Re: CECP Data Adequacy Supplement A, 07-AFC-6

**Subject: Carlsbad Energy Center LLC – Carlsbad Energy Center Project AFC (07-AFC-6):
Data Adequacy Supplement A**

In Response to Data Adequacy Review
of the
Application for Certification
for the
CARLSBAD ENERGY CENTER
PROJECT
DATA ADEQUACY SUPPLEMENT A
(07-AFC-6)

FIGURE TSE1a-1
ONE-LINE DIAGRAM
ENCINA POWER STATION
UNIT 6

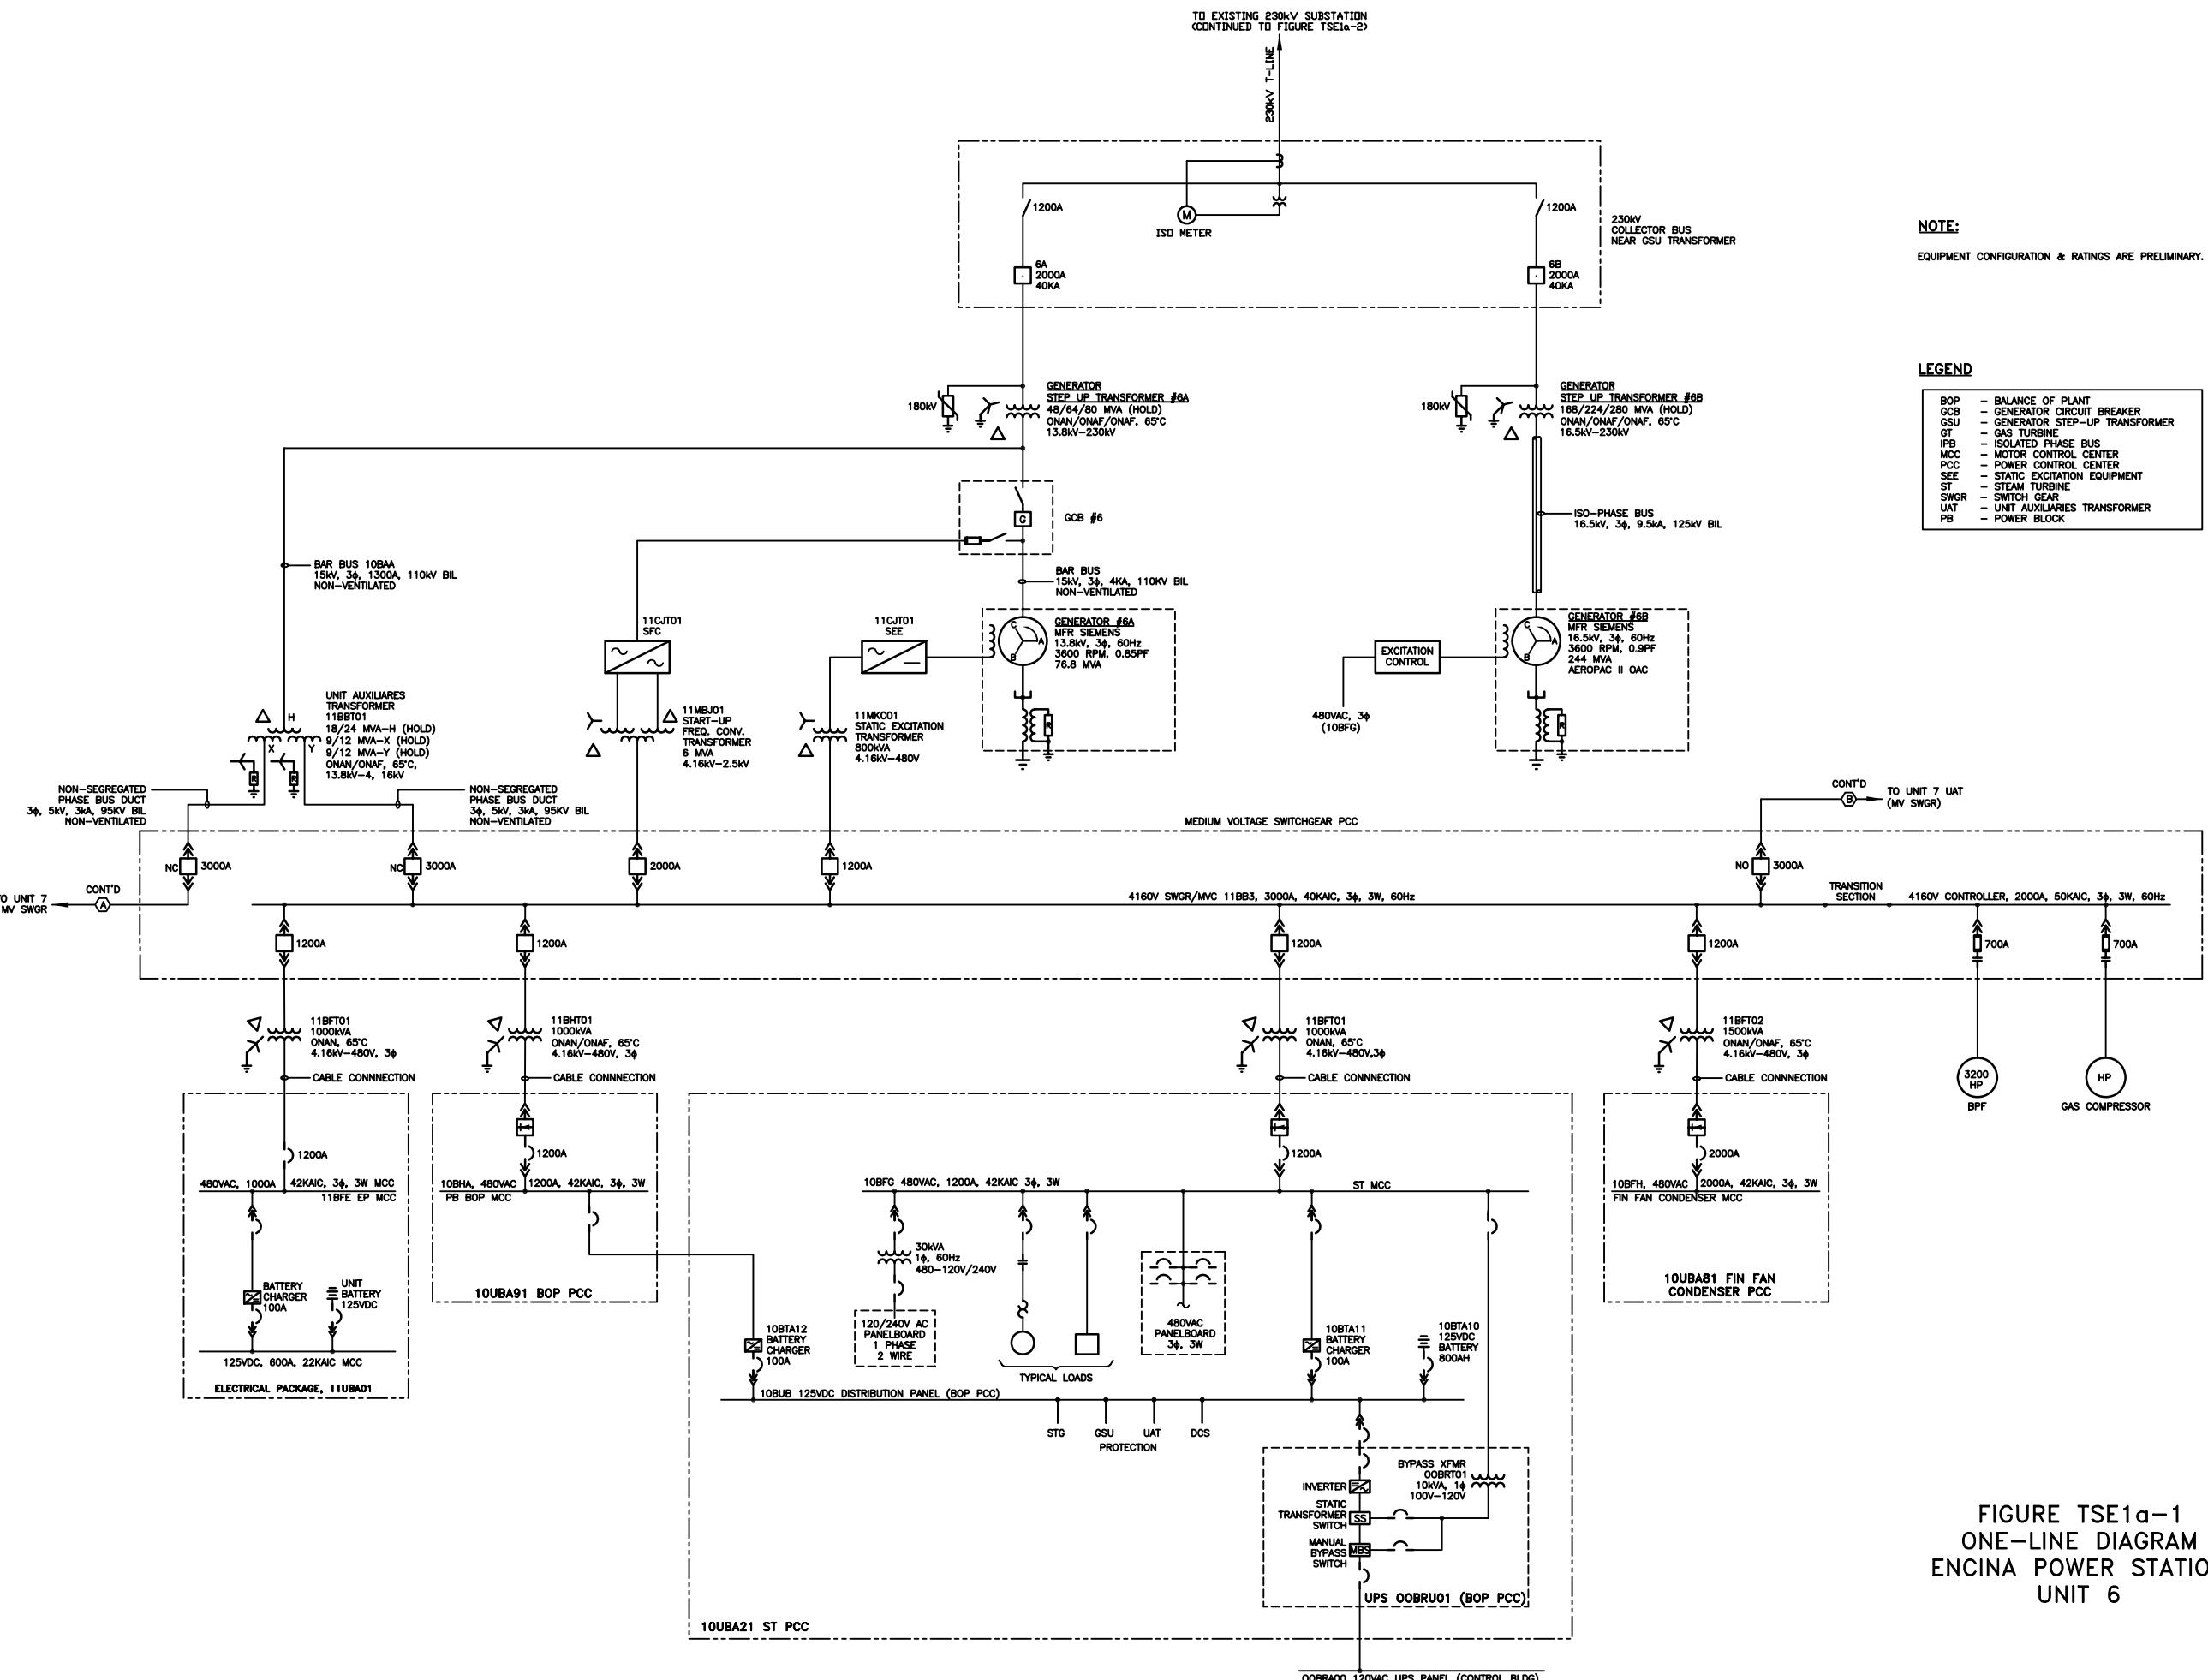
a. Provide a complete electrical one-line diagram (or resubmit Figure 3.1-1) of the proposed Carlsbad Energy Center Project (CECP) 138 kV & 230 kV switchyards or the post-project Encina switchyards showing all equipment for all new generators' interconnection with the switchyard including any bus duct connectors or cables, 13.8 kV switchgear & breakers on the low side, generator step-up transformers, short overhead line and/or cables from the transformers to the switchyards with their configurations, buses, breakers, disconnect switches on the 138 kV & 230 kV sides and their respective ratings, along with the existing/proposed transmission outlets from the switchyards.

Response— As a result of preparing these new figures, the Applicant has also revised the first eight pages of the Transmission System Engineering Section of the AFC. Changes from the original text are shown in underline/~~strikeout~~ mode. The requested figures are provided as Figures TSE1a-1 through TSE1a-4.

FIGURE TSE1b-4
THREE LINE DIAGRAM
ENCINA POWER STATION
UNIT 3

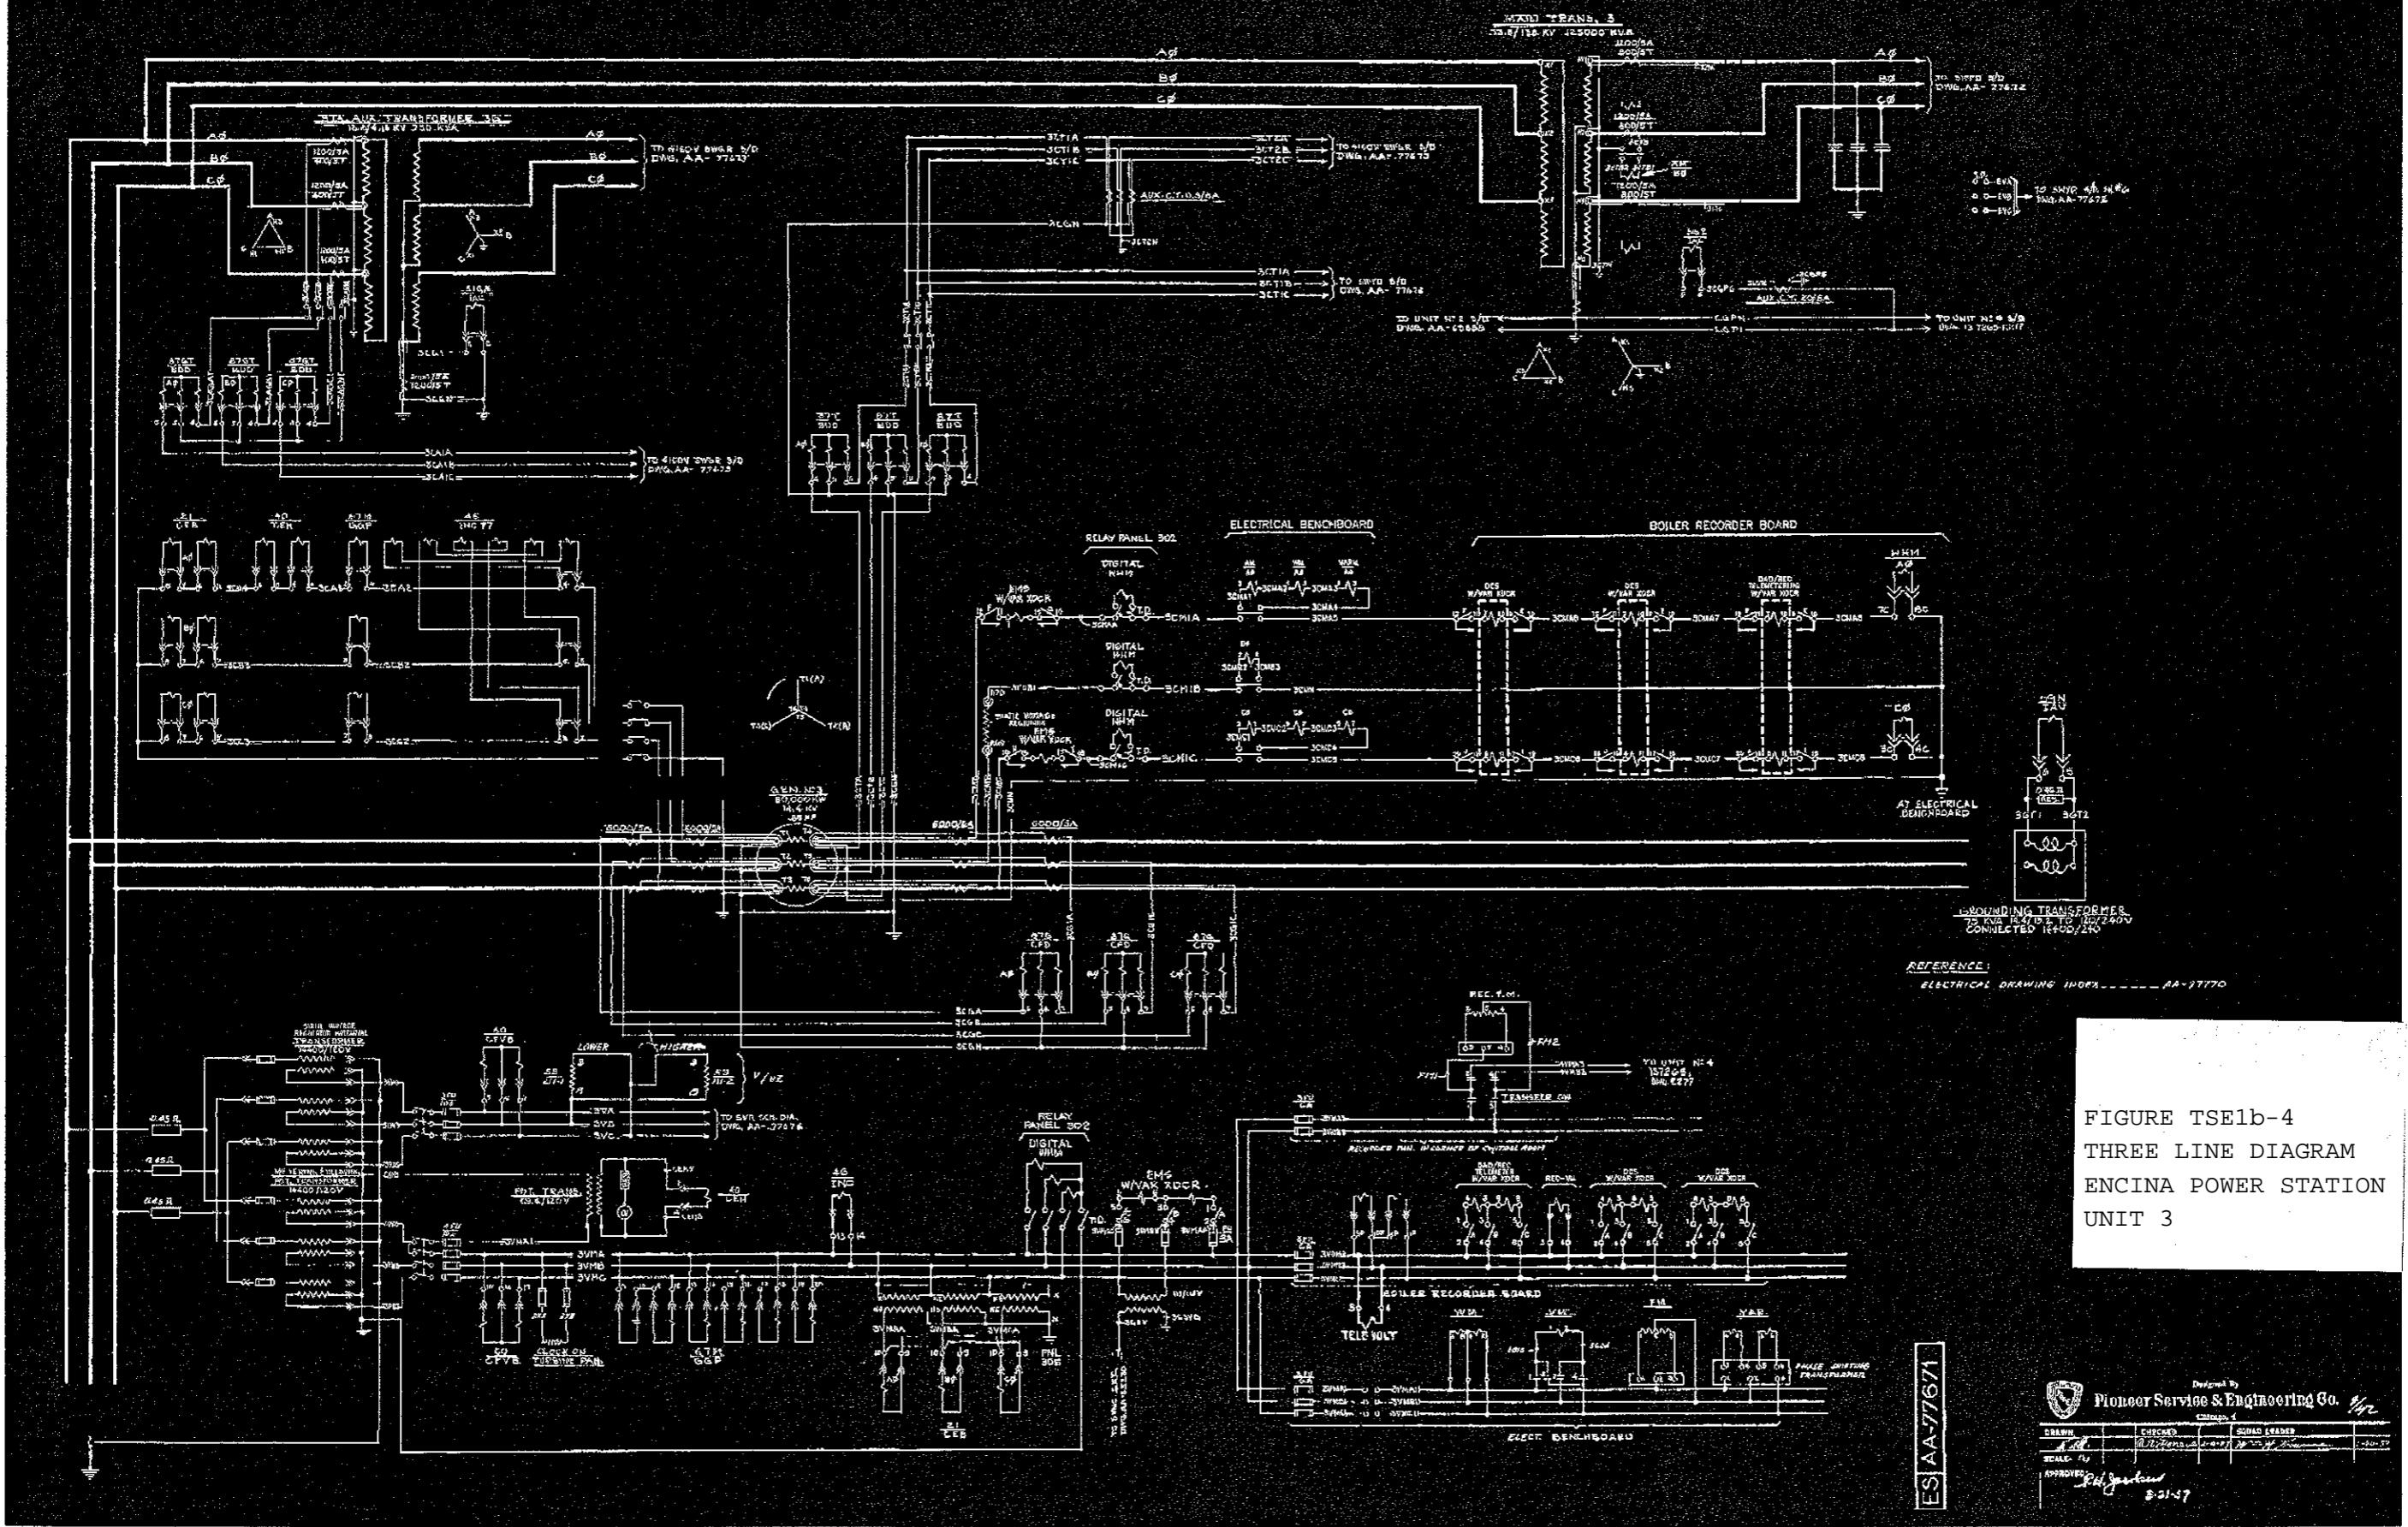
b. Also provide a one-line diagram showing the existing Encina generator units and pre-project existing 138 kV & 230 kV Encina Switchyards with their configurations, buses, breakers with the existing transmission outlets.

Response— The requested figures are provided as Figures TSE1b-1 through TSE1b-7 and are described in the revised text that is attached.
